Record of Decision
Rotron-Woodstock Site
Operable Unit No. 1
Town of Woodstock, Ulster County
Site Number 3-56-009

DECLARATION STATEMENT - RECORD OF DECISION

APPENDIX A
RESPONSIVENESS SUMMARY
OPERABLE UNIT No. 1
ROTRON-WOODSTOCK INACTIVE HAZARDOUS WASTE SITE
I.D. NO. 356009

Figure 2

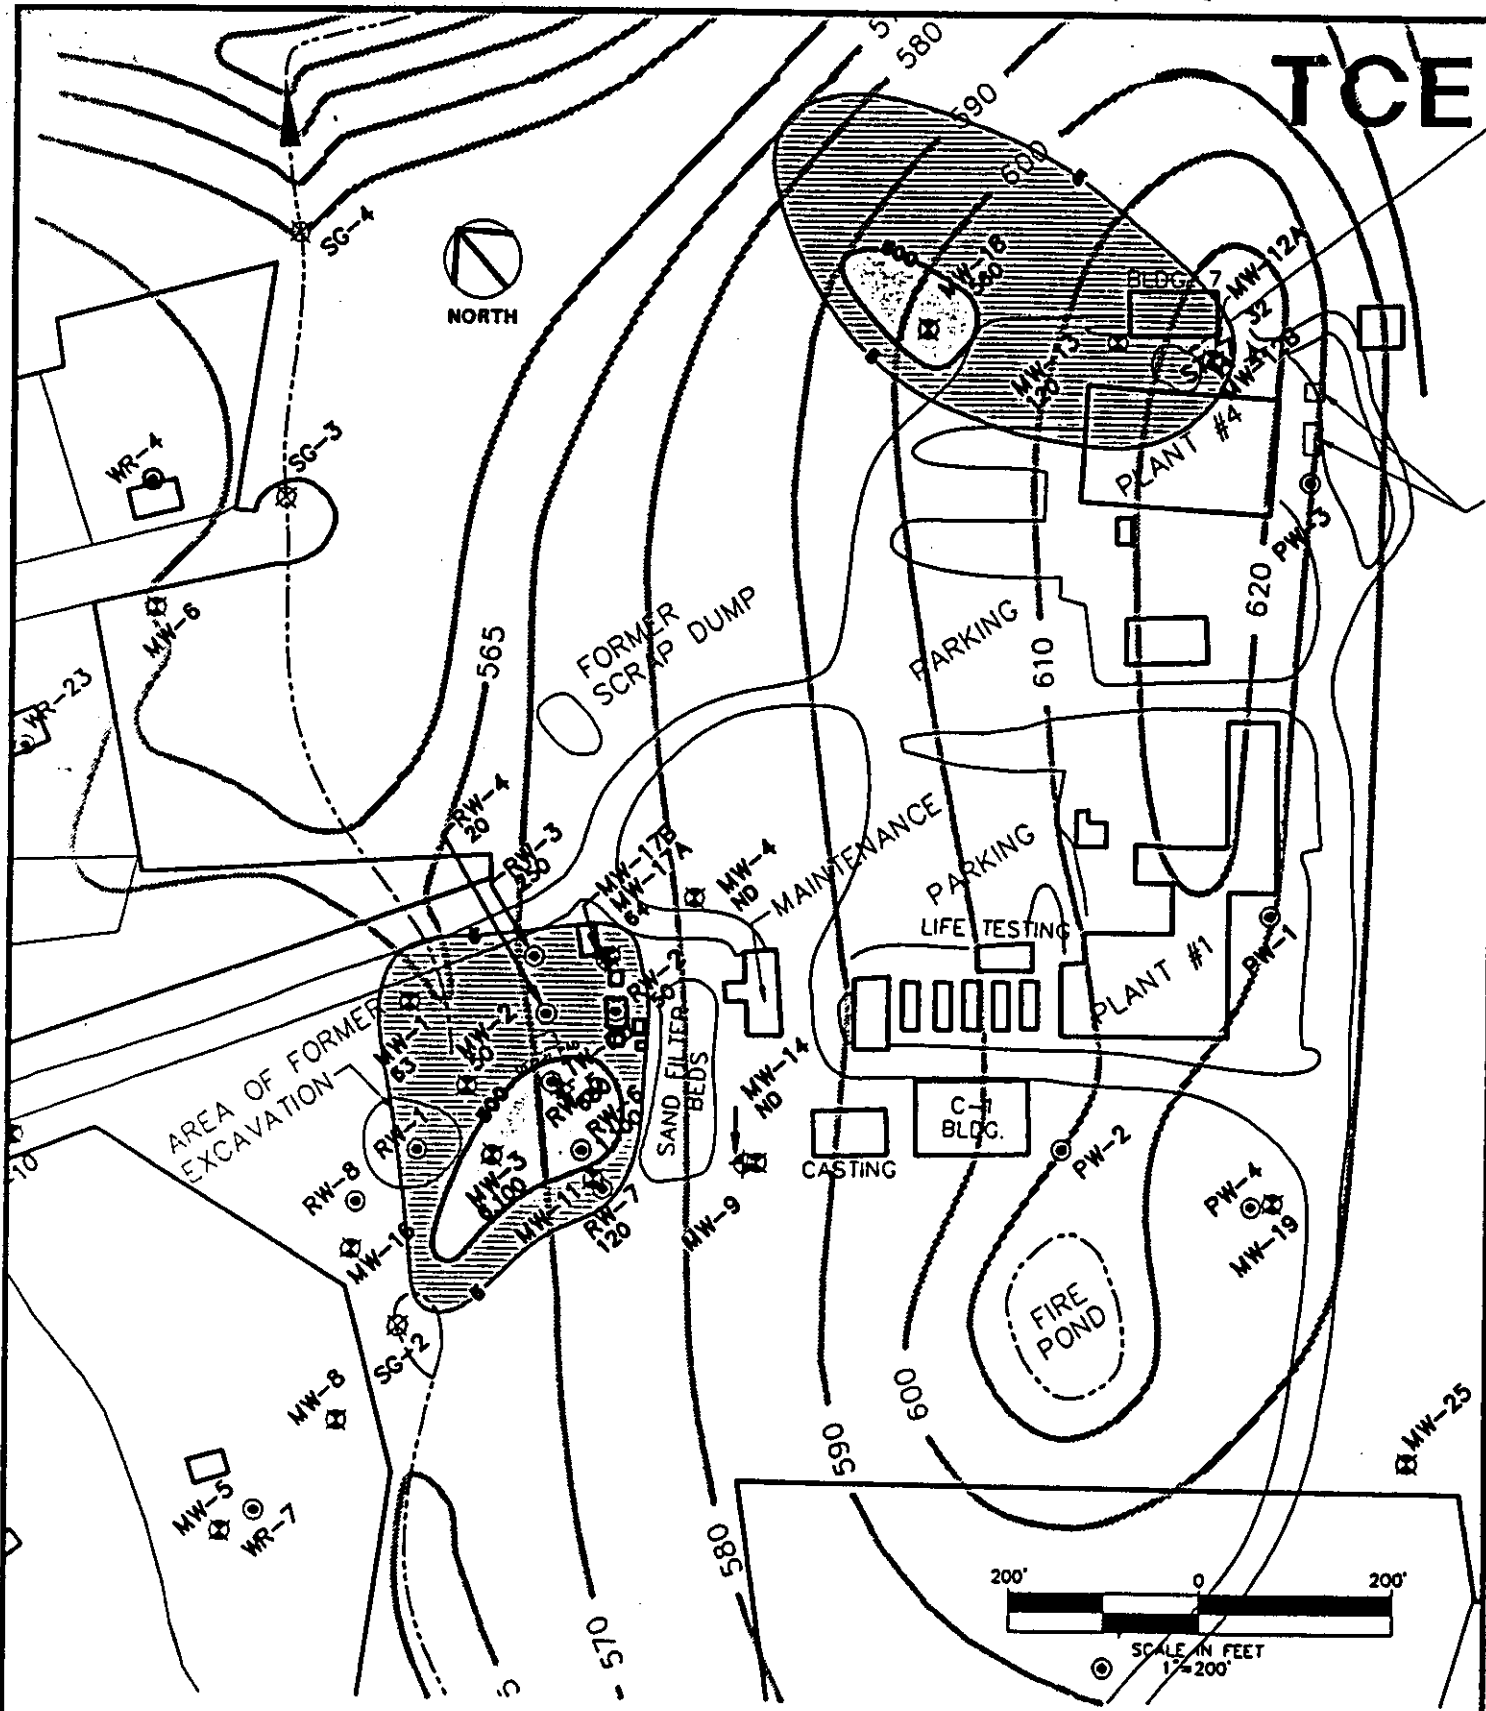
4. **Why is only trichloroethene (TCE) depicted in Figure 2 of the PRAP? Why not include other site contaminants of concern, such as Freon 113 and trichloroethane (TCA)?**

TCE is the primary contaminant of concern for the site. Figure 12 of the RI Report provides separate concentration distributions (or plumes) for TCE, Freon 113, and TCA in the shallow overburden groundwater. Each are similar in nature, so only the TCE plume was presented in the PRAP.

Figure 3

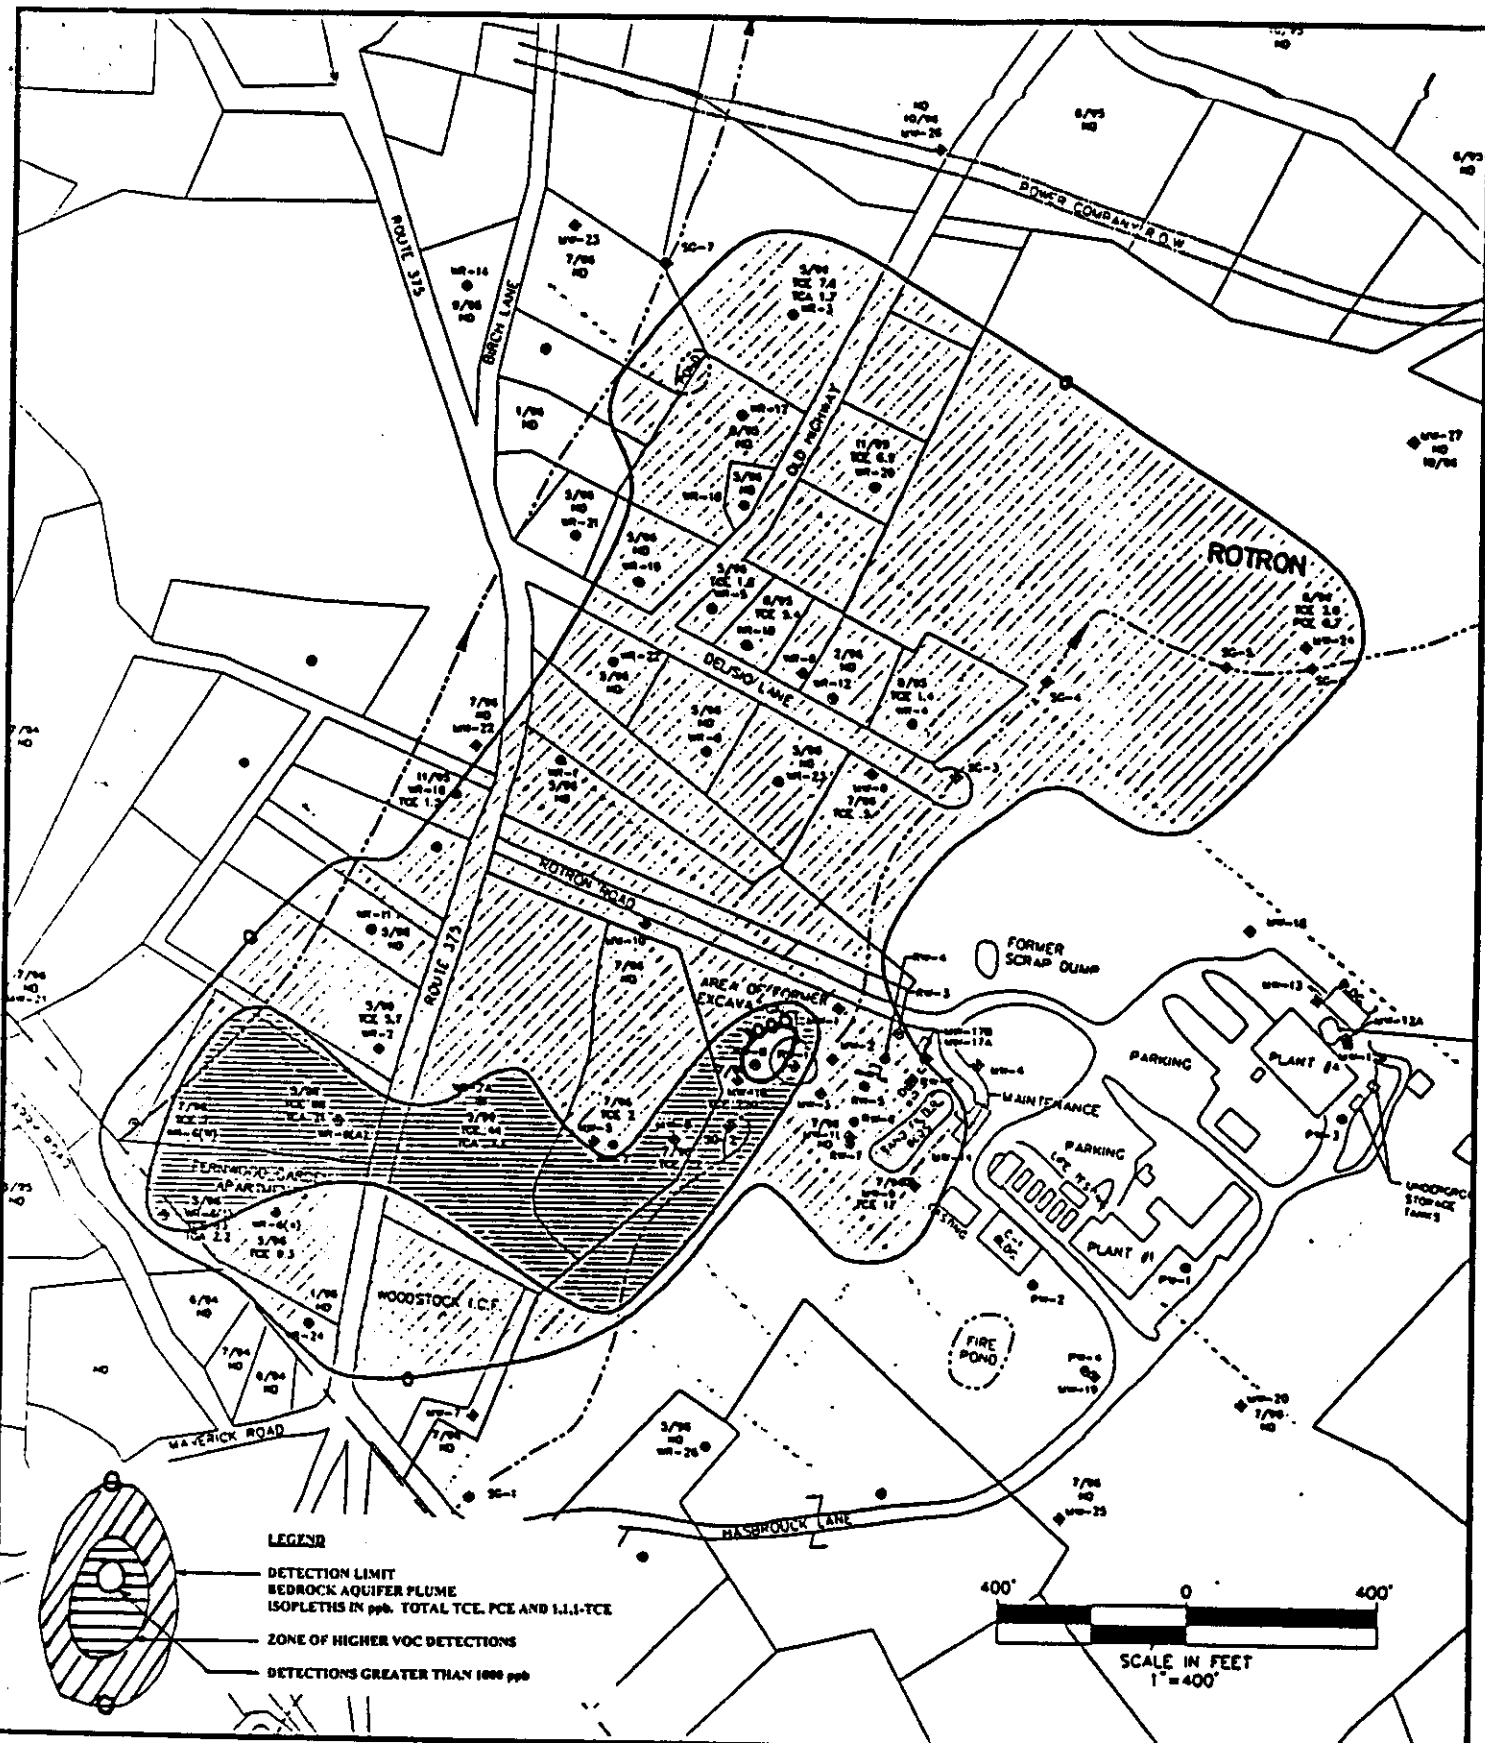
- 2. Has the full extent of the Operable Unit No. 1 bedrock aquifer contamination been determined?**

4. **Why are certain homes that are outside the bedrock plume boundary depicted in Figure 3 of the PRAP included in the area of the expanded water district?**

Yes. This is based on up to three rounds of sampling data from each of the bedrock monitoring wells. Operable Unit No. 1 (OU1) includes bedrock groundwater to the west, south, southeast, and to the north of the Rotron property. Bedrock groundwater to the east and to the northeast of the Rotron property will be addressed in the ongoing Operable Unit No. 2 RI for the site. The extent of the OU1 bedrock groundwater contamination is depicted in Figure 3 of the Record of Decision and Figure 11 of the OU1 RI Report.

Figure 3 depicts the bedrock plume boundary based on data from 1996 private well and monitoring well sampling events. Historically there have been detections of volatile organic compounds (VOCs) in residential wells that now show no detections of VOCs. Some of these residences are located outside the current bedrock plume boundaries. Based on a review of the historical data, the UCHD determined it would be appropriate that these residents and residents immediately adjacent to them be included in the expanded water district boundaries as a precautionary measure.

Figure 4

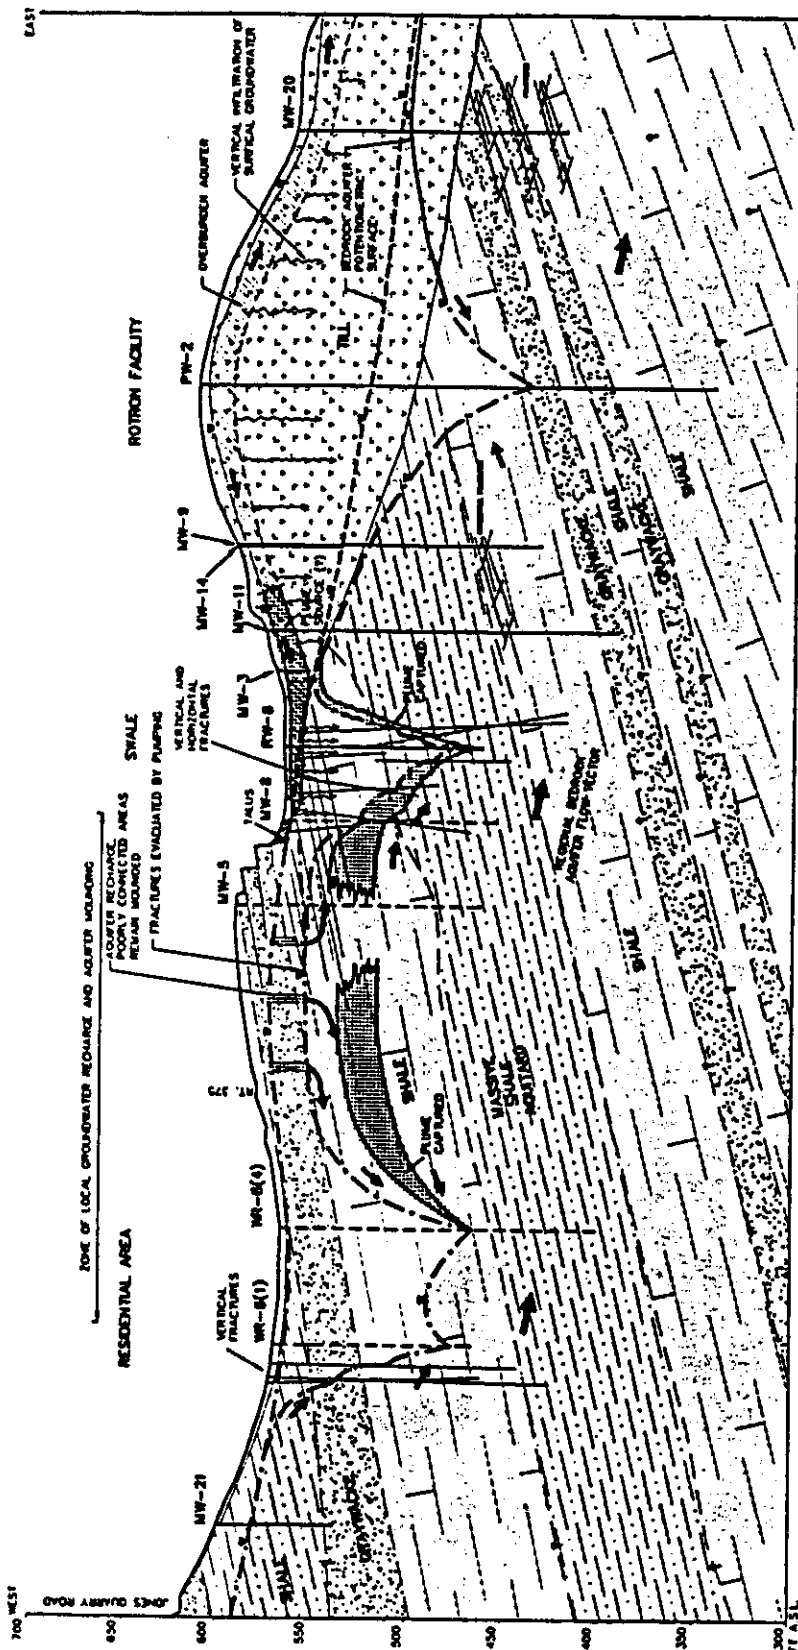
- 1. In reference to Figure 4 of the PRAP, what is the direction of bedrock groundwater flow?**

Under non-stressed bedrock aquifer conditions, without groundwater pumping or returns, the predominant groundwater flow within the bedrock aquifer is expected to be in a eastward or northeastward direction. Due to pumping from wells located both on the Rotron property and to the west of the Rotron property, natural groundwater elevations have been lowered and the bedrock flow direction has been locally reversed, allowing site related contaminants to move westward in the bedrock aquifer. Figure 4 of the PRAP is a west to east cross section of the bedrock aquifer and is designed to graphically explain current bedrock groundwater conditions and the effect that recovery well RW-8 will have in preventing further contaminant migration to the west. The Remedial Investigation (RI) Report discusses this issue in much more detail and Figures 10(A), 10(B) and 10(C) of the RI Report present conceptual hydrogeologic cross sections for the site.

Figure 5

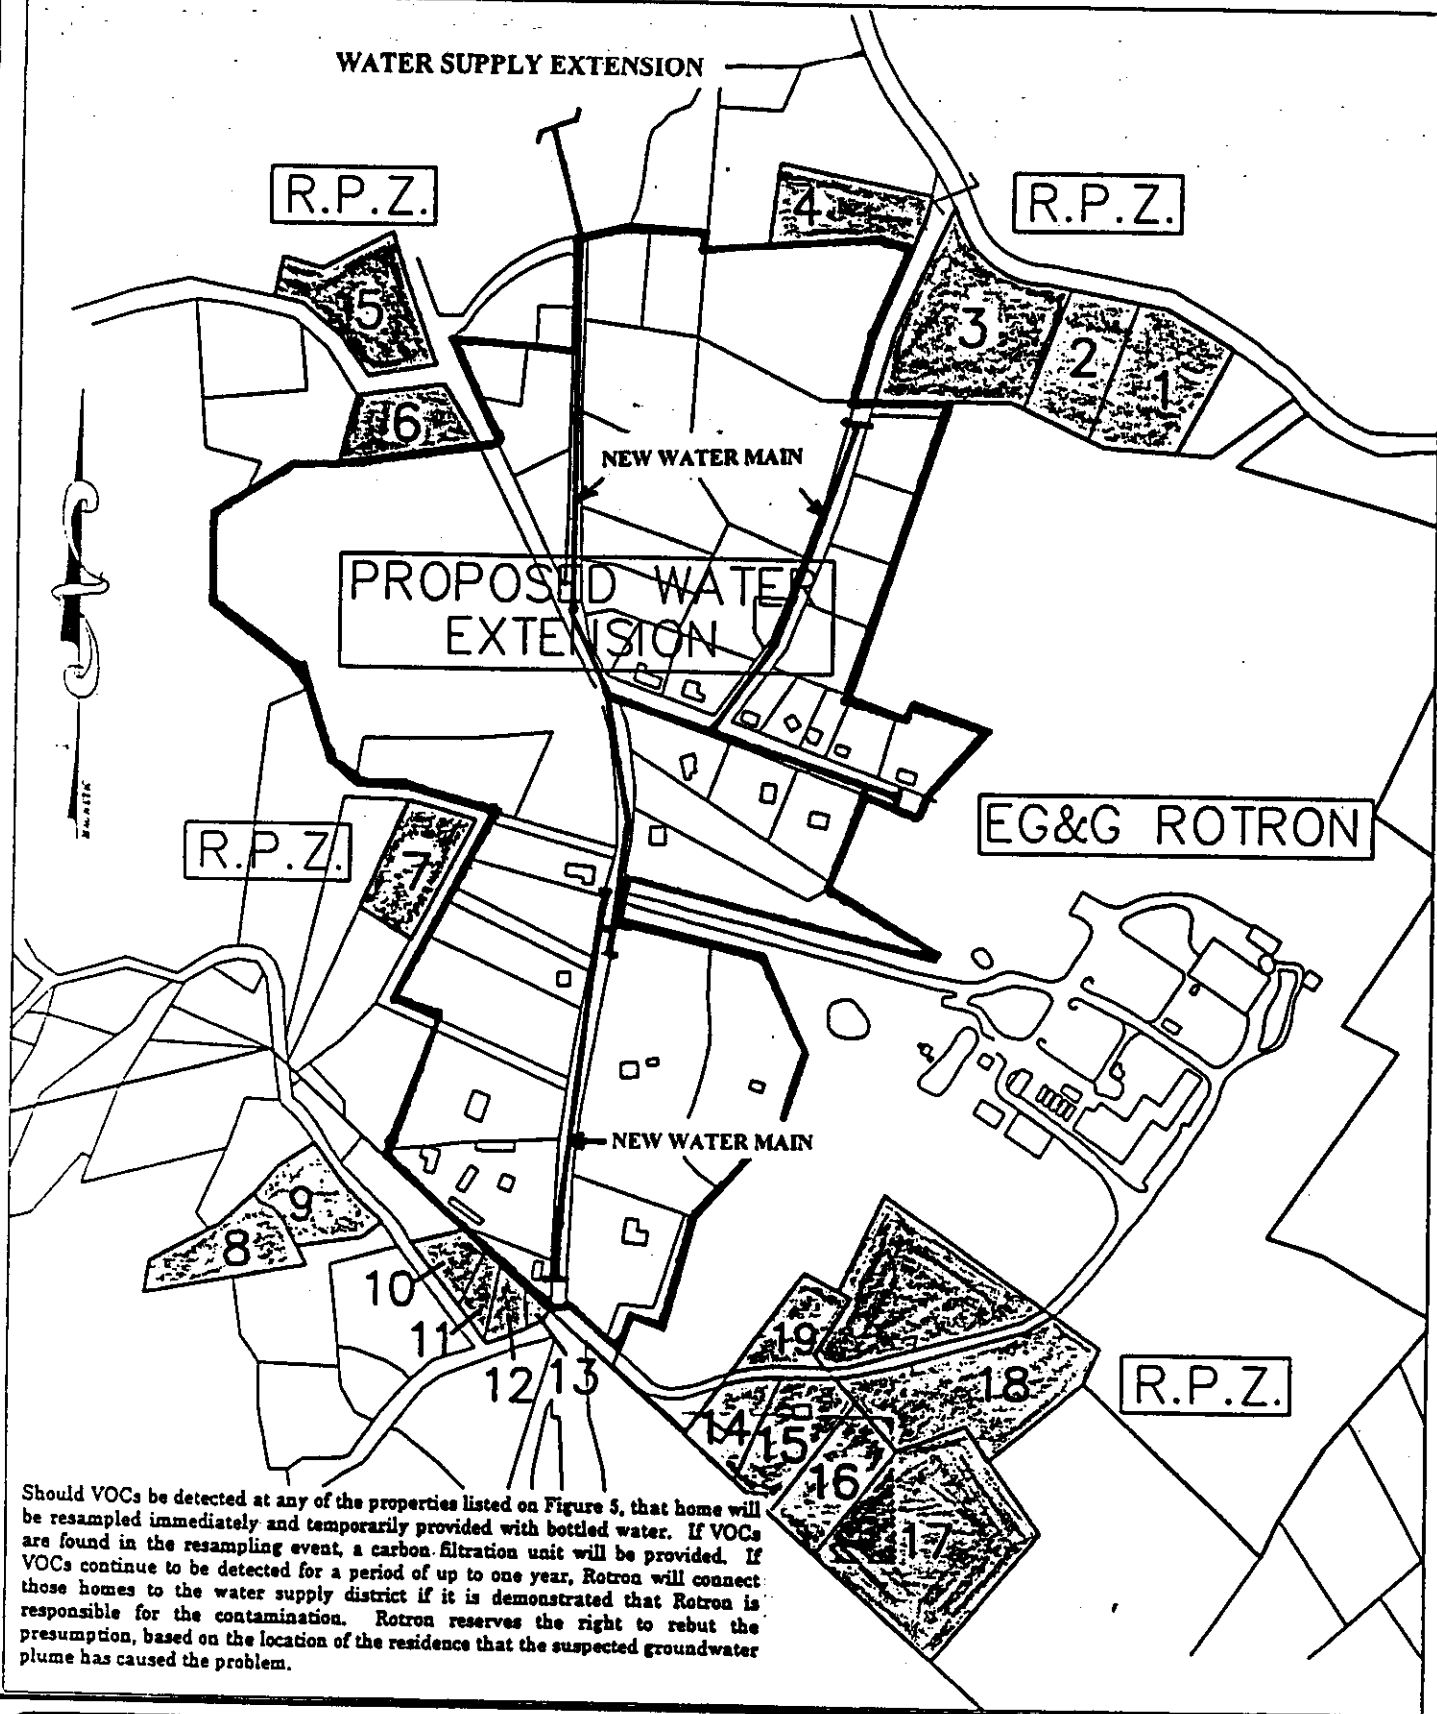
2. **How does the Rebuttable Presumption Zone (RPZ) work?**

Based on the agreements between Rotron, Inc. and the members of the Citizens for Clean Water (CCW), after the installation of the water supply extension, groundwater will continue to be monitored at a number of residences along the perimeter of the expanded water district for a period of two years on a quarterly basis. The residences included in this sampling program make up the Rebuttable Presumption Zone (RPZ).

The specific residences are identified as properties 1 through 19 in Figure 5 of the Record of Decision.

Although the actual agreements have remained confidential between Rotron, Inc. and the members of the CCW, they are reported to state that should VOCs be detected in any of the numbered properties identified on Figure 5, those home will be resampled immediately and temporarily provided with bottled water. If VOCs are found in the resampling event, a carbon filtration unit will be provided. If VOCs continue to be detected for a period of up to one year, Rotron will fund the connection of those homes to the water supply district if it is demonstrated that Rotron is responsible for the contamination. Rotron reserves the right to rebut the presumption, based on the location of the residence that the Rotron VOC groundwater plume has caused the problem. In such a rebuttal, Rotron shall consider the chemical "fingerprint", groundwater flow direction, geology and hydrogeology, proximity to the spill zone and other relevant factors.
